Subject: **Workplan for Monitoring Well Installation and Letter Response**  
Bernard's Gas  
1051 Airway Blvd  
Livermore, California  
Apex Project No. NWP01.001

Subject: Fuel Leak Case No. RO0002440, Bernard's Gas, 1051 Airway Blvd., Livermore, CA – Request for Work Plan

DRAWN BY: J. Curry	<b>PROPOSED SOIL BORING LOCATION MAP</b>	<b>FIGURE 3</b>
	DATE: 10/04/05		
	REVISIONS	Bernard's Gas 1051 Airway Boulevard Livermore, California	PROJECT NUMBER:
			NWP01.001

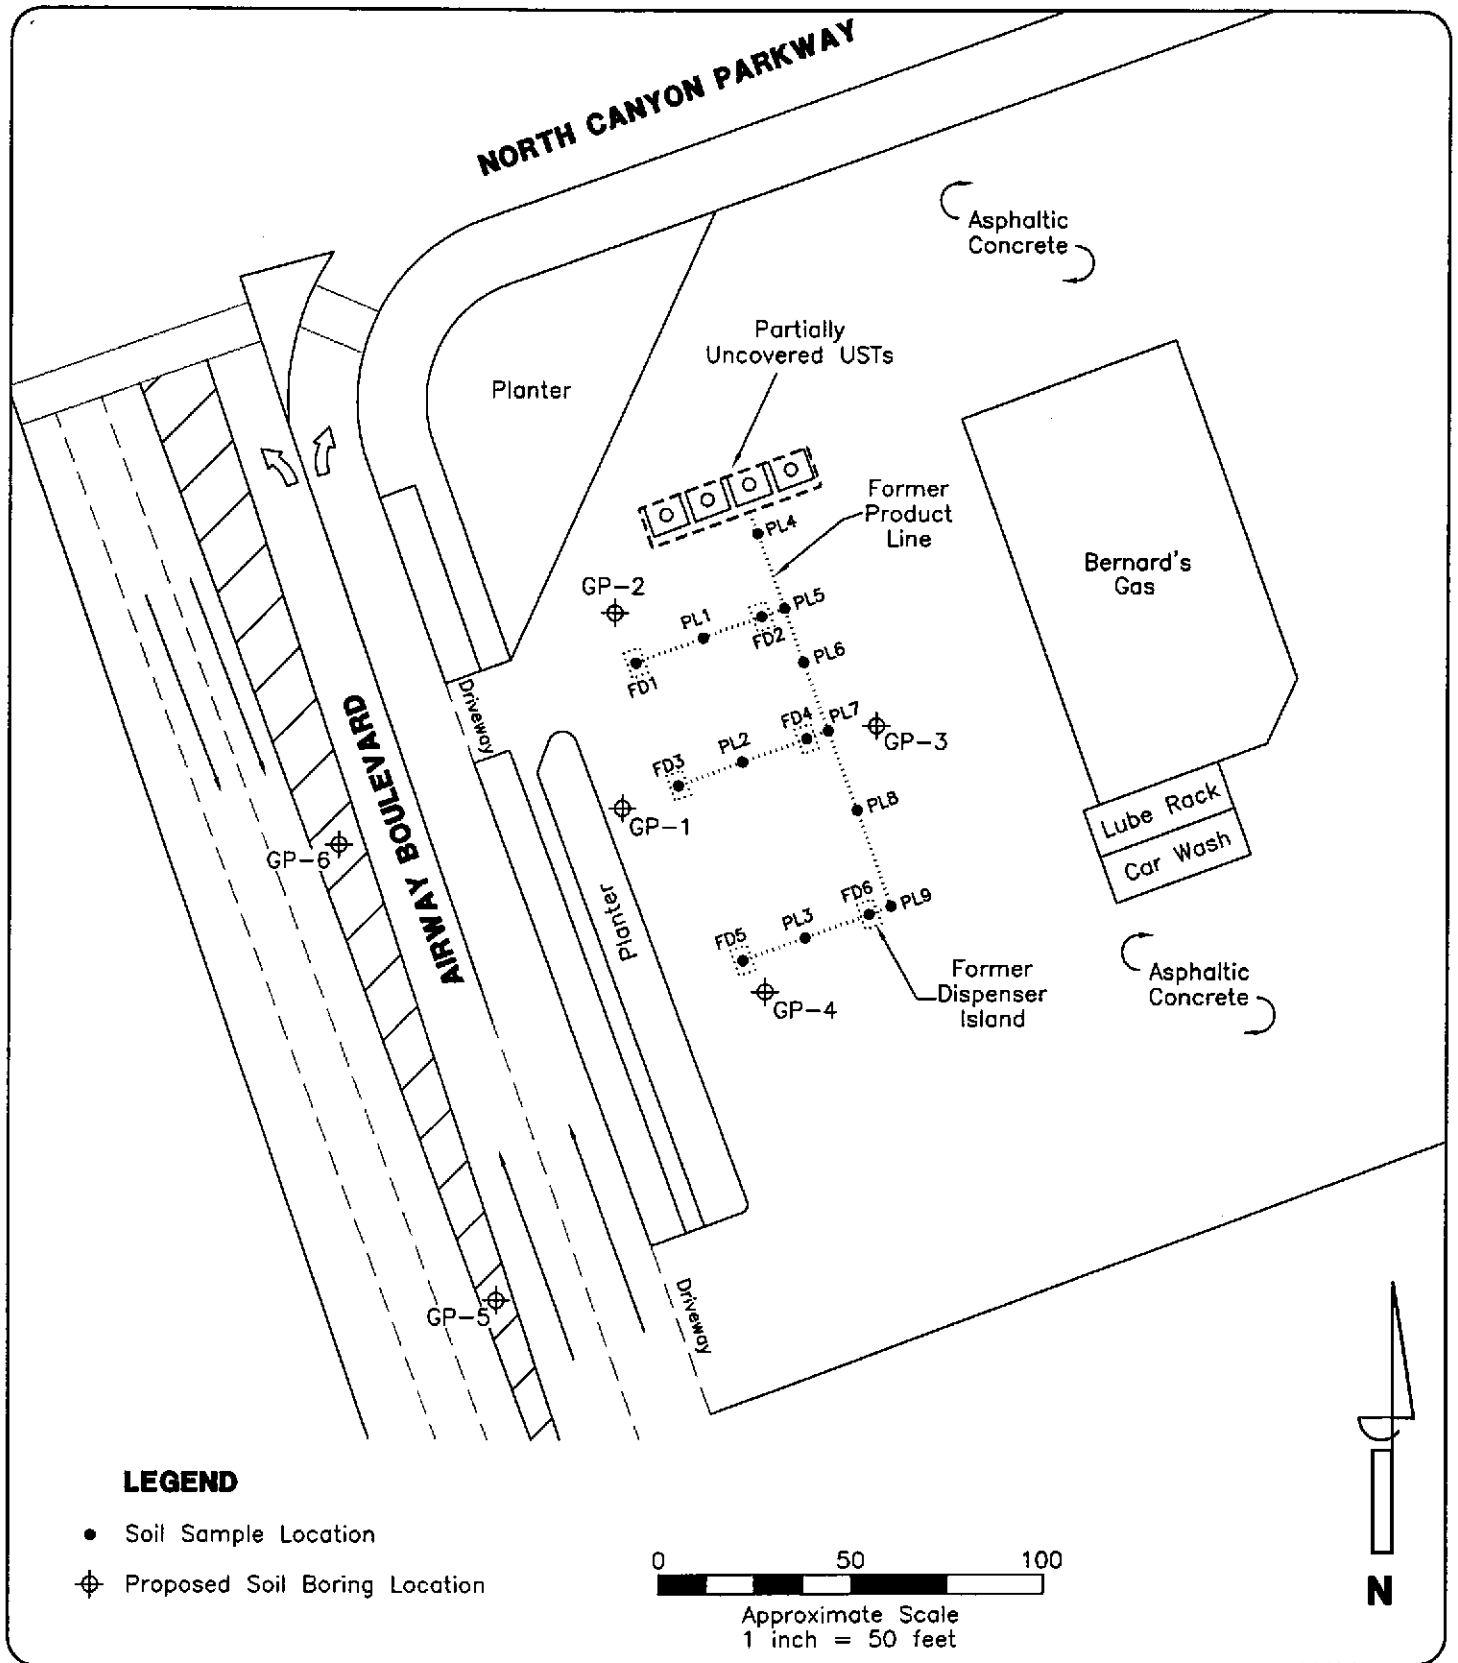
Previous reports submitted to date for this site have included soil boring logs for borings GP-1 and GP-2 only. Please submit soil boring logs for borings GP-3 and GP-4 in the Work Plan requested below.

Please submit a detailed work plan detailing your proposal to fully characterize the lateral and vertical extent of soil and groundwater contamination. The Work Plan should be prepared by a qualified professional and must fully describe the proposed scope and methods for the soil and groundwater investigation.

Include your proposal for the installation of wells/piezometers in the work plan requested below. We request that wells be installed in transects. Please refer to the guidance document by API Publication No. 4730 referenced above regarding transects. We recommend that you submit your proposal for the installation of monitoring wells/well clusters and piezometers to ACEH for comment prior to installation. Report on the installation of wells/piezometers in the Soil and Groundwater Investigation Report.

Apex proposes installing six shallow groundwater monitoring wells and one deep monitoring well (Figure 3). Depth to groundwater is approximately 27 feet-bgs. The proposed wells will be installed utilizing a hollow stem auger rig and completed as 2-inch diameter monitoring wells using Schedule 40 PVC and screened with 0.020-inch slotted screen. Shallow zone wells MW-

1, MW-2, MW-3, MW-4, MW-6, and MW-7 will be completed to 35-feet bgs and screened from 20 to 35 feet bgs. Wells MW-2, MW-3, MW-6, and MW-7 are located on-site. The location of wells MW-1 and MW-4 is proposed in the center divide non-traffic area of Airway Boulevard as shown on Figure 3. Well MW-5 will be installed as a deep well to an unknown depth to be determined in the field. Total depth of deep well MW-5 will be determined in the field pending subsurface conditions and the well will utilize a 5-foot screened interval. Subsurface conditions will be determined by continuously coring the bore hole from 35-feet until a viable second aquifer zone is determined.
